### **EPML00418713 Information Request Response**

Monto Coal 2 Pty Ltd (Monto Coal) submitted an application to amend Environmental Authority (EA) EPML00418713 for the Monto Coal Project (MCP) on 22 February 2021 to the Department of Environment and Science (DES). The purpose of the EA amendment is to add Mining Lease (ML) 80175, add Environmentally Relevant Activities (ERAs), and amend several conditions. An Information Request was received by Monto Coal on 12 May 2021, with a due date of 12 November 2021.

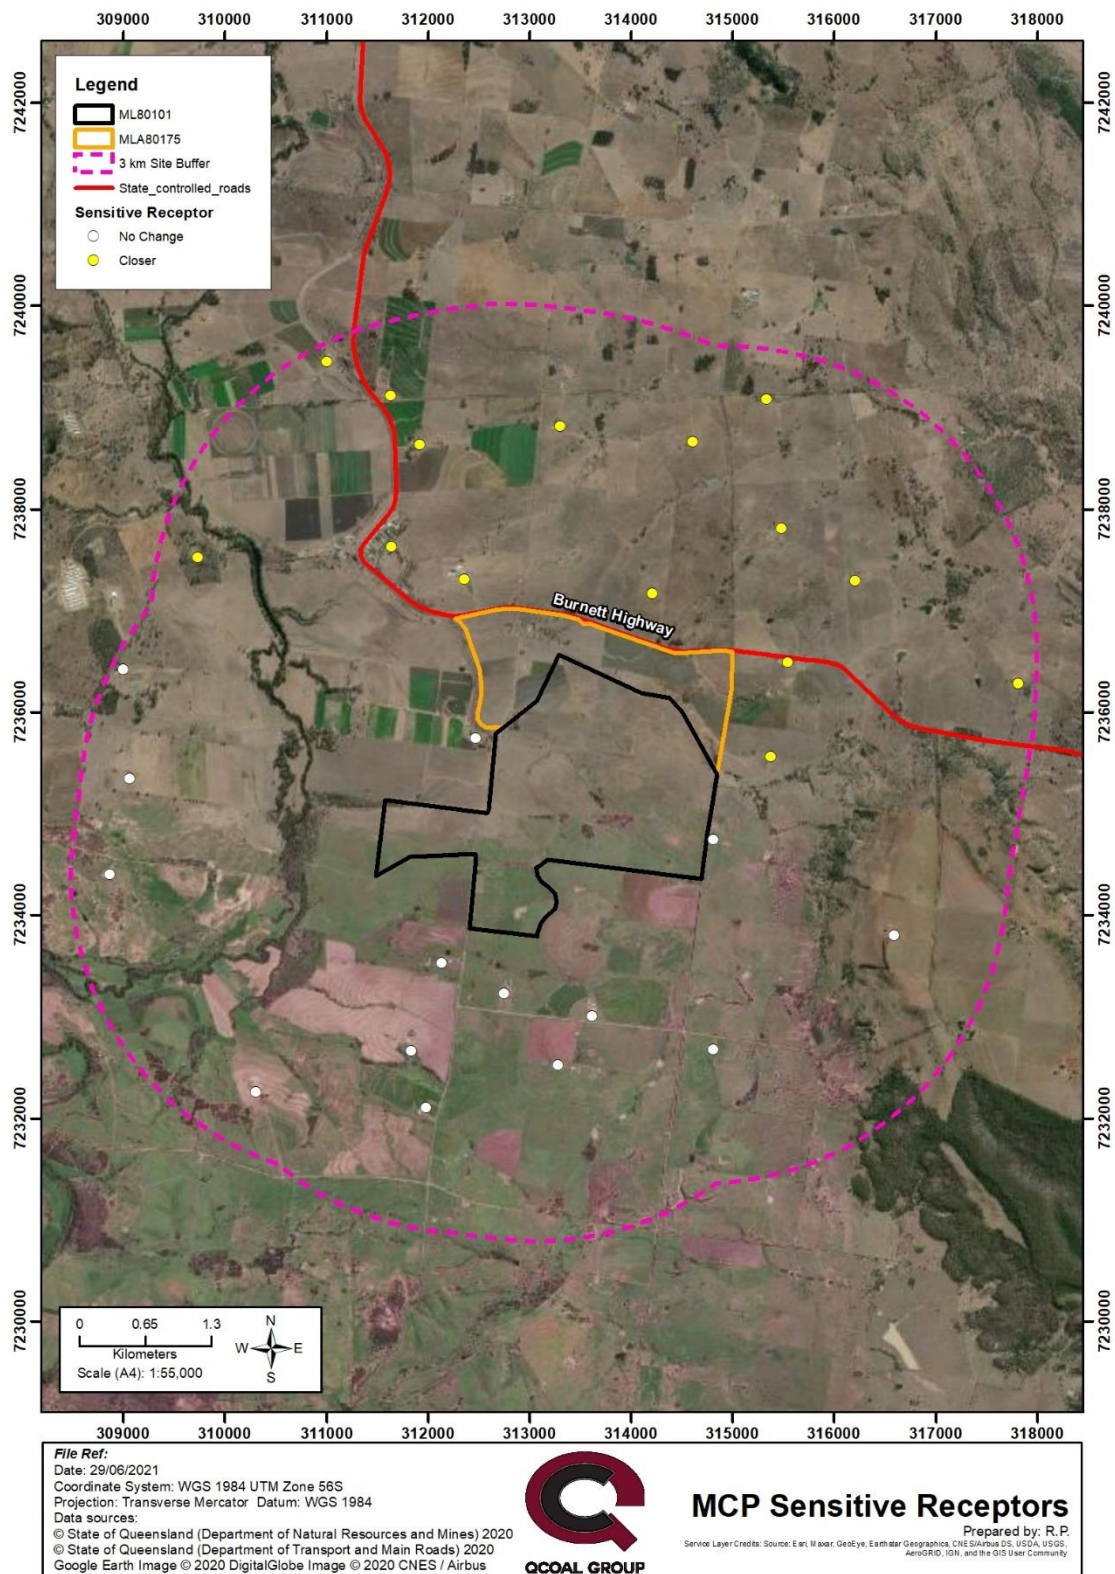
*The proposed amendment will expand mining activities northward to be closer in proximity to sensitive receptors identified for previous approval of activities on ML80101.*

*However, the impacts to EVs of noise, vibration and air at these sensitive receptors due to the proposed expansion are unclear.*

*Identify the sensitive receptors which will become closer in proximity to the Project.*

*Confirm if the Project will remain compliant with the existing limits and associated conditions of EA EPML00418713 for EVs of Acoustics and Air.*

*Provide confirmation for example, via modelling which demonstrates the level of impact to sensitive receptors under the proposed amendment. Modelling should describe the individual potential impacts of noise, vibration and dust at each sensitive receptor.*

The sensitive receptors map (Figure 15 in the supporting document) has been revised to identify which receptors will be located in closer proximity to the MCP as a result of the addition of ML 80175 and is presented below.

The majority of mining operations at the MCP will be undertaken within the original ML80101 footprint, with ML 80175 only containing a small waste rock dump, a sediment dam, and a northern extension of the “pre-existing” pit. The initial box-cut and mining areas within the MCP will be within the previously approved ML 80101. Advancement of the pit and active mining within ML 80175 is not planned to be undertaken until year five (5) of the operation at the earliest, giving Monto Coal at least four (4) years of operational monitoring data collection, refinement of mitigation measures and ongoing community engagement to ensure that the EA conditions can be achieved and impacts on sensitive receptors are minimised.

Modelling of noise, vibration and dust has not been undertaken for the addition of ML 80175, as it would not provide any additional regulatory, monitoring or management outcomes. This is primarily because monitoring trigger limits at the location of a receptor are based on the receptor itself, which remains unchanged regardless of the mining activity. For example, a noise limit at a homestead remains applicable (based on persons living there) regardless of the where a mining activity is being undertaken.

Additionally, the potential impacts associated with activities within ML 80175 are not materially greater (in terms of generating noise, dust or vibration) than those already approved to be undertaken on ML 80101 by the EA.
